**STAFF REPORT**  
(One-Step Final Plat)

**CASE NUMBER:** SUB 2001-23 -- REGAL MOTORS ADDITION

**LOCATION:** East side of Broadway, North of 31st St. South

**VICINITY MAP**

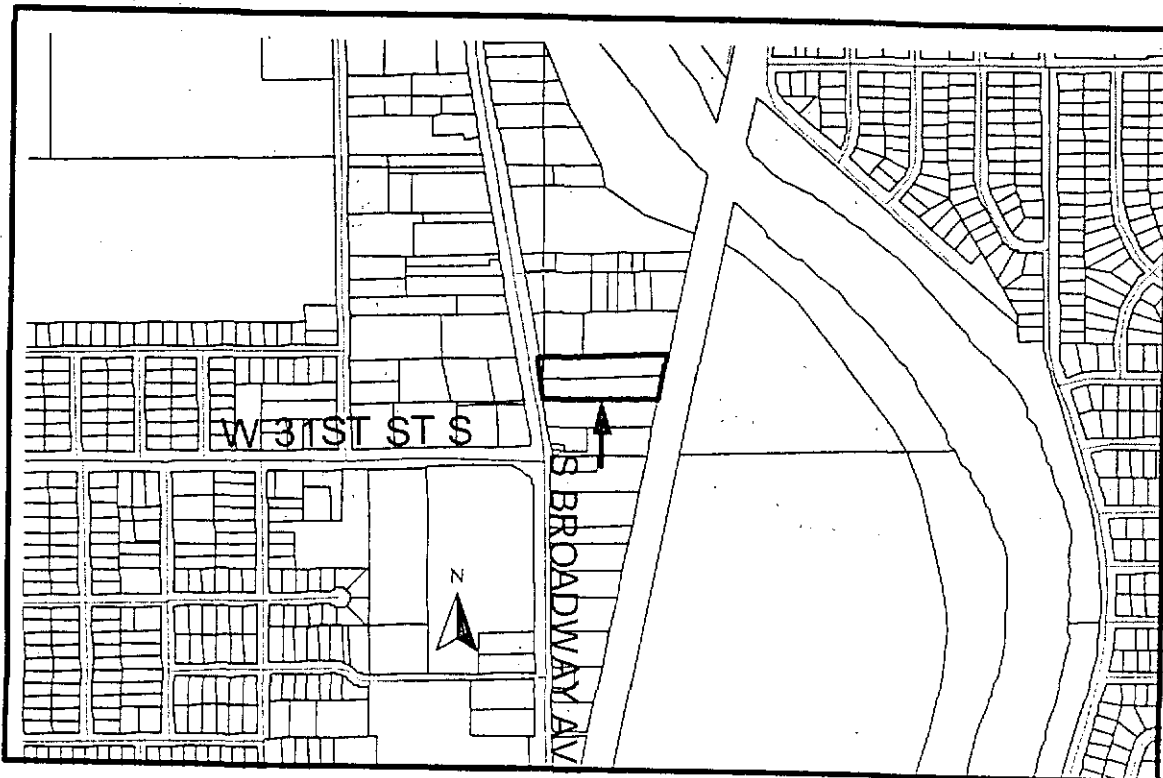
- C. City Engineering needs to comment on the status of the applicant's drainage plan.
- D. The plat proposes two access openings along Broadway. Traffic Engineering needs to comment on the access controls particularly the need for a joint access with the adjoining property to the north.

- E. The centerline of Broadway needs to be denoted on the final plat tracing.
- F. The right-of-way width from the centerline of Broadway needs to be denoted on the final plat tracing. The Subdivision Regulations require a 50-ft half-street right-of-way for plats along arterials.

- K. The current ownership of the railroad needs to be included on the plat.
- L. This property is within a zone identified by the City Engineers' office as likely to have groundwater at some or all times within 10 feet of the ground surface elevation. Building with specially engineered foundations or with the lowest floor opening above groundwater is recommended, and owners seeking building permits on this property will be similarly advised. More detailed information on recorded groundwater elevations in the vicinity of this property is available in the City Engineers' office.
